10/561,540

<b>Office Action Summary</b>	<b>Application No.</b> 10/561,540	<b>Applicant(s)</b> DA SILVA GONCALVES ET AL.	
	<b>Examiner</b> Denise R. Anderson	<b>Art Unit</b> 1797

### **DETAILED ACTION**

**Specification Fig. 1 Compared to Lee et al., Figs. 13 and 18****Claim 1, steps (a) – (c) disclosed.**

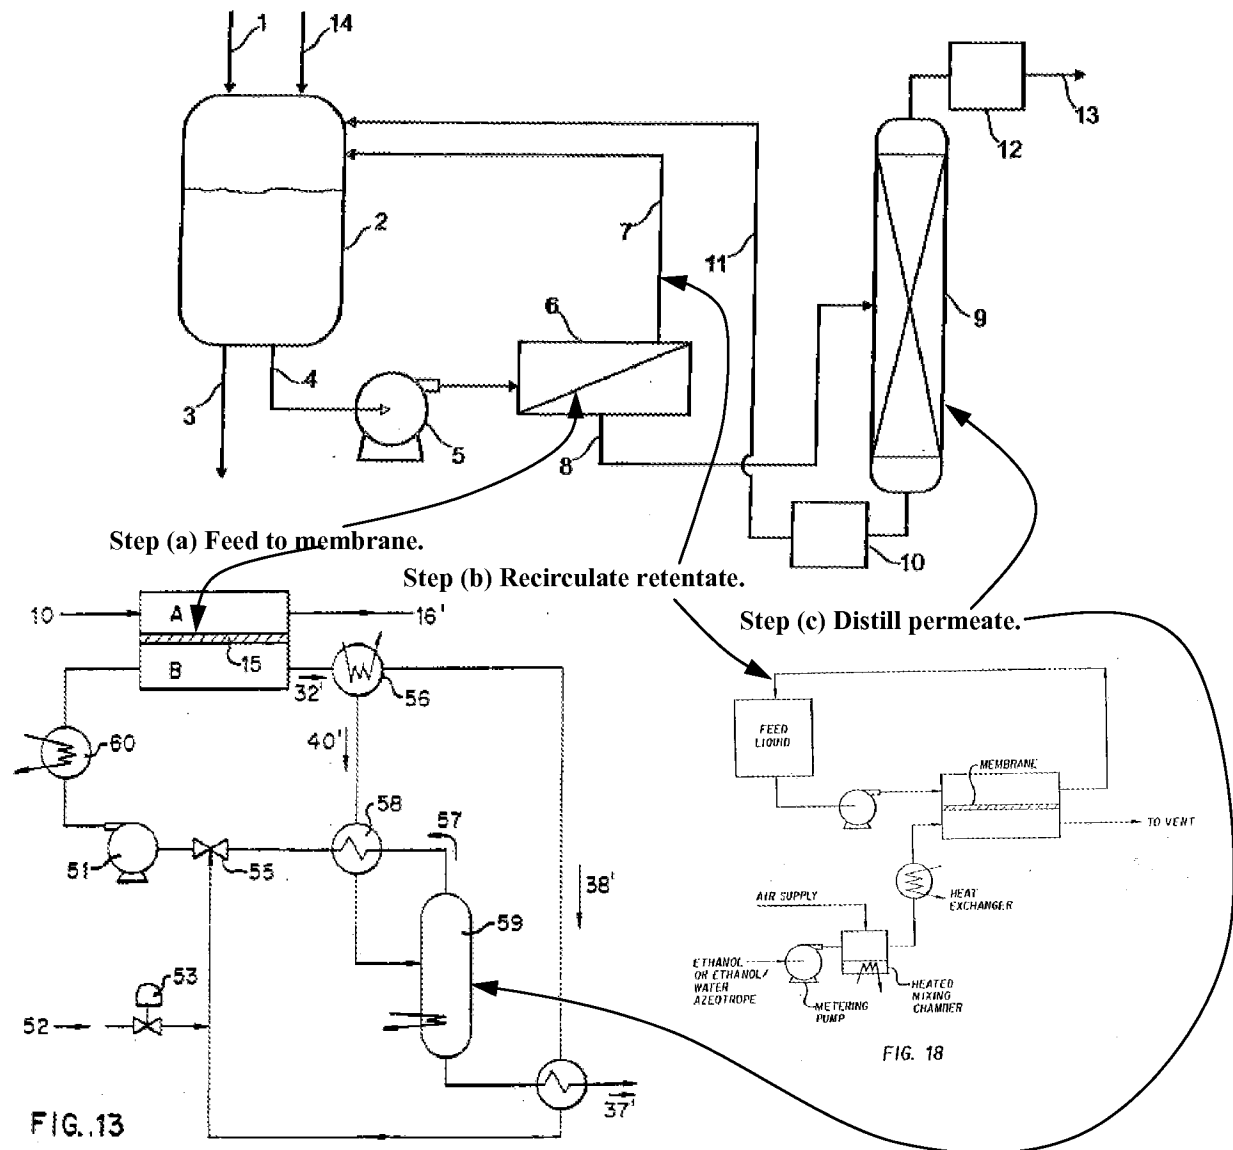
Claim 1 is shown below with the pressure limitation underlined. Claim 1, as recited, can be interpreted as either a pressure-mediated process or a pervaporation process with pressure-mediation and permselectivity. Lee et al. discloses both processes in the Background section to reduce alcoholic content of beverages -- along with fermentation control methods, evaporation methods, membrane distillation methods and solvent extraction with membrane extraction methods. Lee et al., col. 1, lines 23-31.

Applicant's process is shown below and compared to that of Lee et al. for steps (a)-(c). Steps (d) and (e) are disclosed by Lee et al., as discussed afterwards.

In summary, applicant is arguing that while both processes include membranes, applicant's process is distinguished from that of the prior art because applicant's membrane functions only by pressure-mediation while Lee et al.'s membrane functions by both pressure-mediation and permselectivity. The examiner responded with two points. First, claim 1 does not distinguish between the two processes. Second, as shown in the above patentability analysis above and recapped here, Lee et al. anticipates claim 1. As such, the rejection is maintained.
